Kansas Department of Agriculture
 Division of Water Resources
WAIVER REQUEST & WAIVER RULE WORKSHEET

Date: 12/29/16
Re: File No. 25,196-D2

RE: Water Right, File Nos. 4,809; 15,288 & 25,196-D2

**APPROVAL OF APPLICATION
FOR
CHANGE IN POINT OF DIVERSION
WATER RIGHT
FILE NO. 25,196-D2**

4809, 15288, 25196 - D2

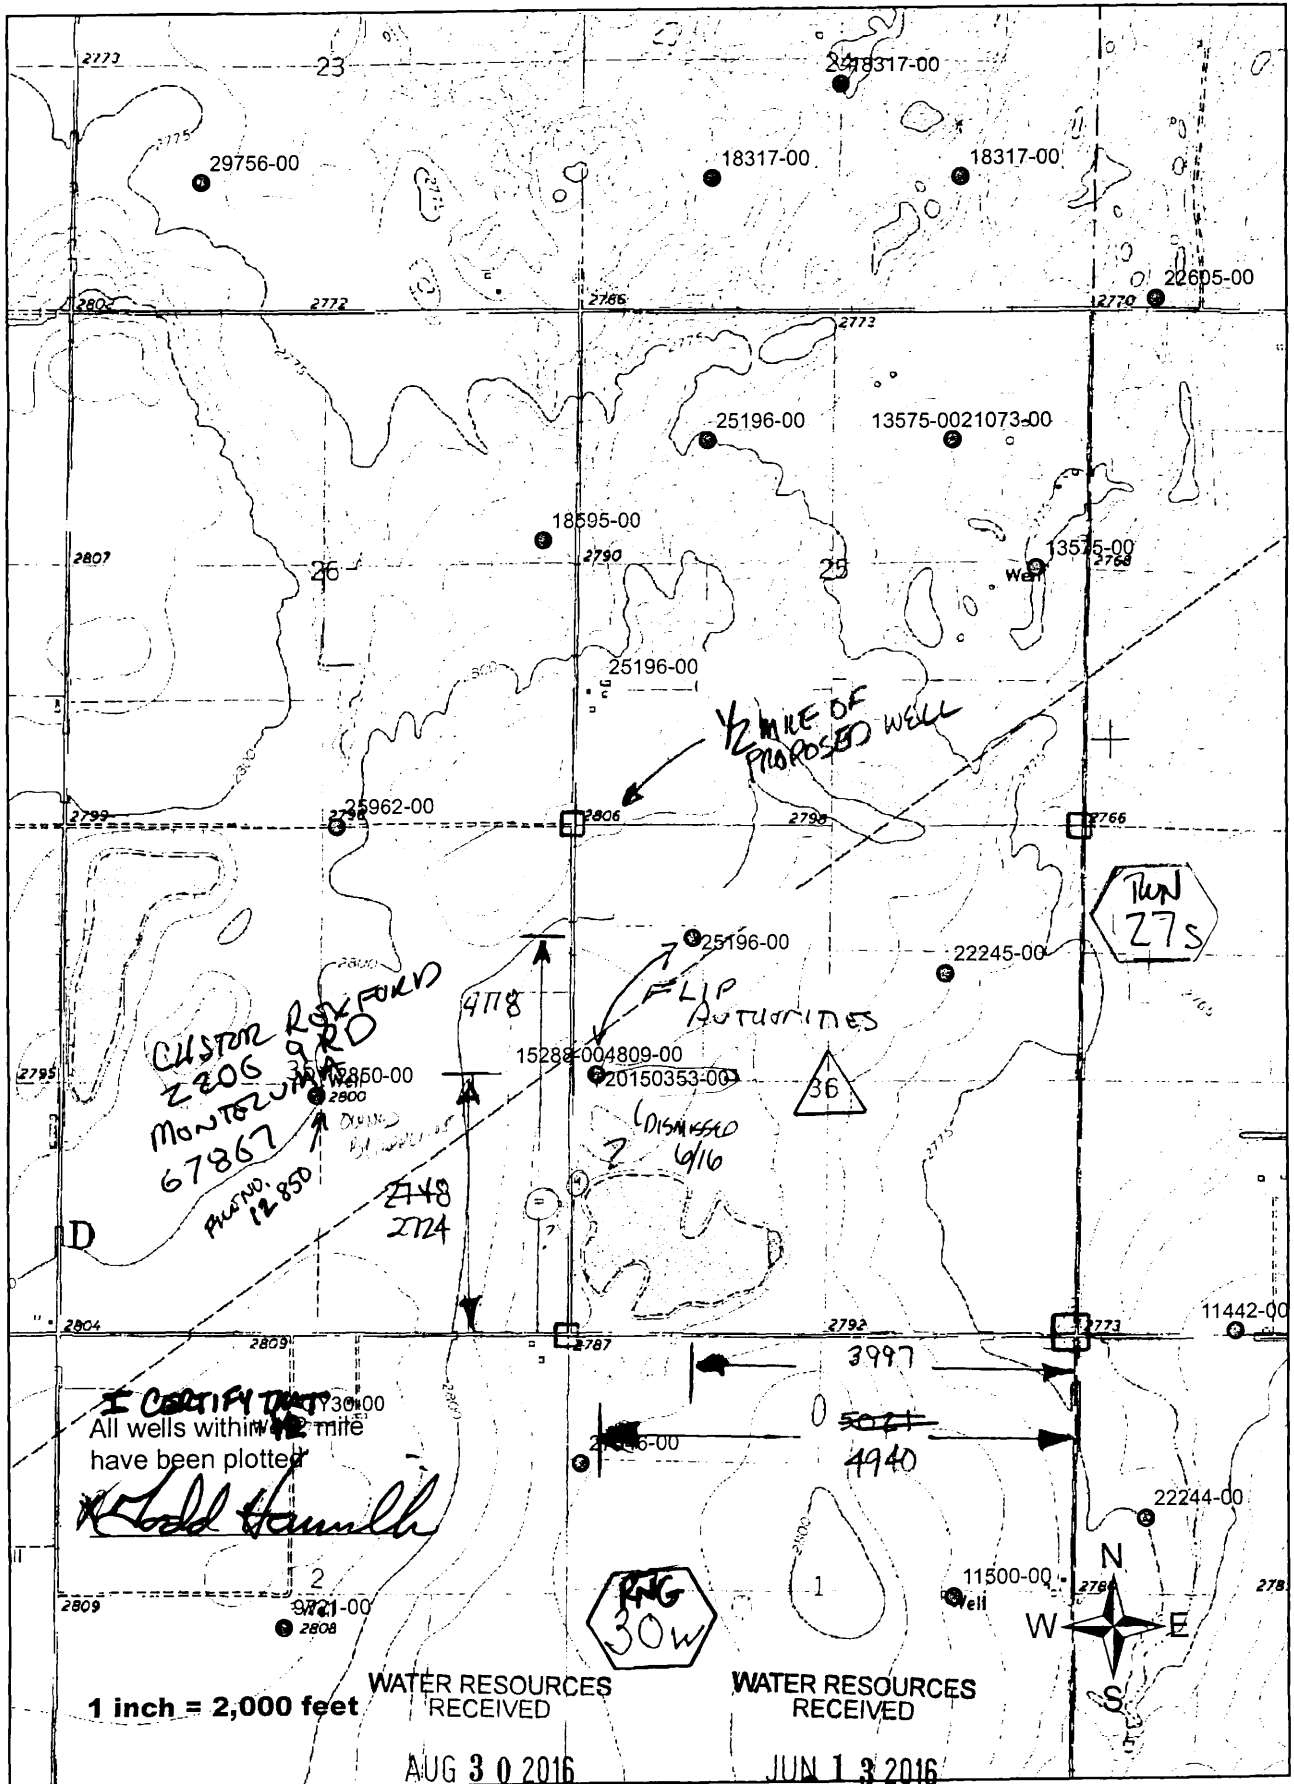
I CERTIFY THAT
All wells within 1/2 mile
have been plotted

wells do not meet spacing to each other.

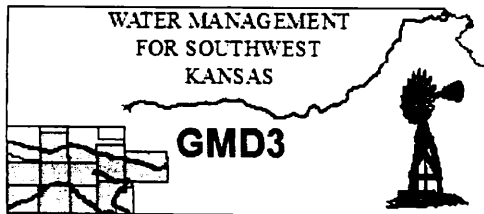
These changes will flip the rights between existing wells. The overlap between File Nos. 4809 & 15,288 will remain as they move to the North, with 25196-D2 moving to the southwest well.

No comments were received from the nearby,,, Koehn or Rexford.

GMD 3 recommended approval with a waiver of well to well spacing per their Nov. 10 letter

I recommend approval but would like to comment in the memo that approval of these applications allow more water to be pumped with the larger well now authorizing the larger water right. This has been a chasing of water from the previously changes to move these rights to the current location from previously dry wells.
